FLOOR PLAN — REV 0

THE PORCH IS AN ELL

REV 0 · 22 SEP 2026 8:57 AM · OFF YOUR THREE PHOTOS
ANCHORED ON THE 12×24 GARAGE

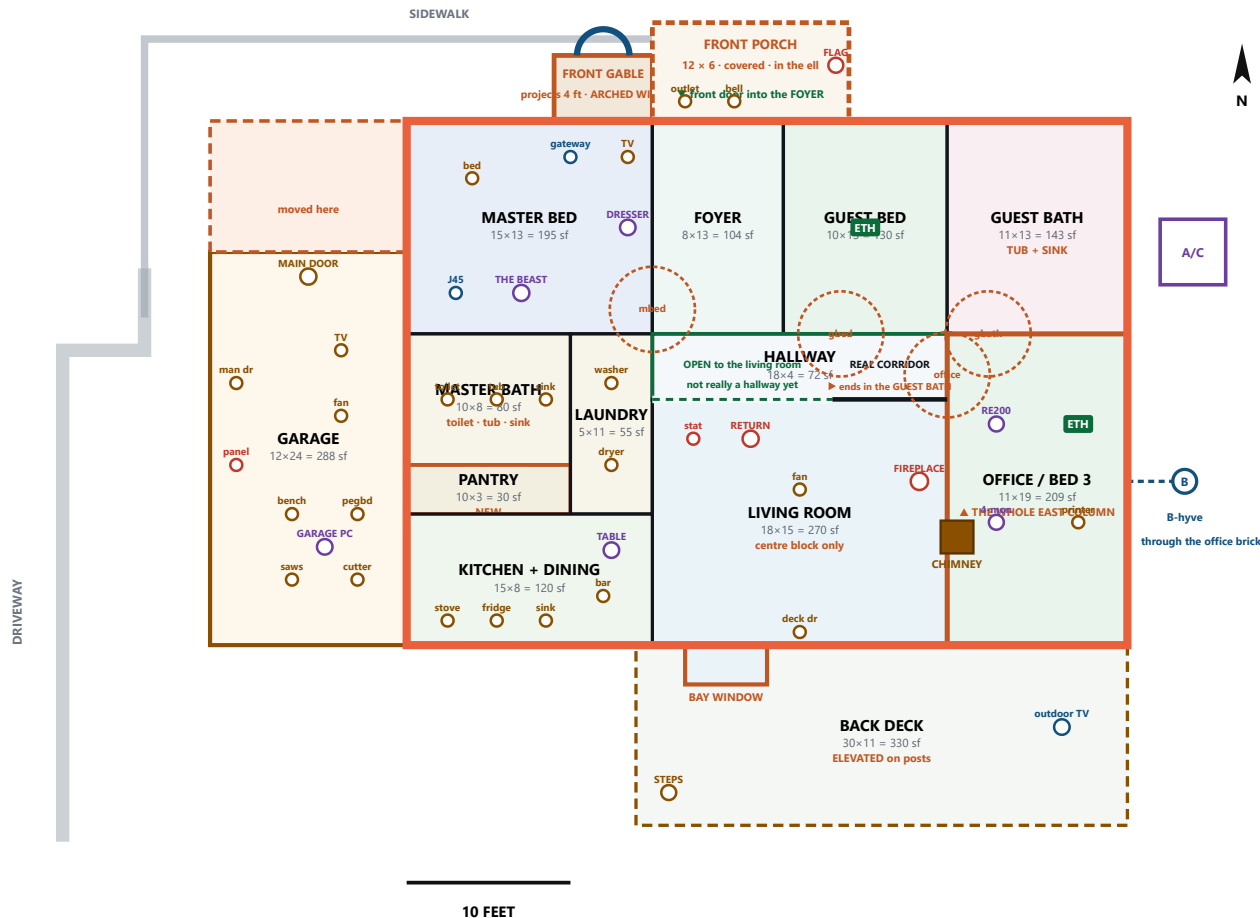
A projecting front gable with an arched window — so the porch is tucked BESIDE it, not carved out of the house.

No floor area is lost, and your 12×8 was right. Plus a bay window on the rear that was never on the plan, the flag moved to its real pier, and the rear windows re-placed off the elevation.

The driveway shot shows a **PROJECTING FRONT GABLE** with a tall arched window, and the porch sits beside it. That is the piece I was missing, and it dissolves the square-footage problem I asked you about.

The porch is not carved out of the house — it is tucked into the ell **BESIDE** a wing that sticks out. The brick on both sides in the doorbell shot is the gable's side wall on one hand and the porch's own return on the other. So **no heated floor area is lost**, and the house stays at **1,408 sf**.

✓ And it means your 12 × 8 was right and my 8 × 6 was wrong. The two railing sections either side of the step read as about **12 ft across the opening**. Drawn **12 wide × 6 deep**. If it is 8 ft deep rather than 6, say so — nothing else on the plan moves, because it sits outside the heated box now.

✓ 9:01 AM — “it’s not really a hallway until the living room ends, and the hallway ends in the guest bathroom.” Drawn that way now: the west stretch has no south wall at all — it is simply the open north edge of

the living room — and it becomes a **real walled corridor** only where the living room stops, running east and **terminating at the guest bathroom door**. That door has moved from the guest bath's west wall to its **south wall, at the end of the corridor**. I **guessed the changeover at 11 ft along** — mark where it really is.

- 🕸️ **A BAY WINDOW projecting off the rear**, just west of the deck door, with its own little hipped roof. **It was not on the plan at all**. Drawn 5 ft wide, projecting 2.5 ft.
- 🏠 **The FLAG is on the porch's EAST brick pier**, hanging out over the lawn — I had it sitting on the porch ceiling line. Moved.
- 🏠 **Rear windows re-placed off the actual elevation**: one small one in the blank brick at the garage end, then the bay, then the deck door, then **three window groups running east — and those east ones are the OFFICE's**. An office that is also Bed 3, with its own windows and deck frontage, is exactly what the photo shows.
- 🛠️ **Deck trimmed** to finish at the east wall instead of running past it, and the outdoor TV pulled in to where it actually sits.

- **The PANTRY** — 10×3 off the south end of the master bath, where your arrow pointed. Position and size are mine, not yours.
- **Where the front gable actually sits.** I put it just west of the porch, over the master bedroom, because that is the order the driveway shot reads in. **If the gable is east of the porch instead, flip the two.**
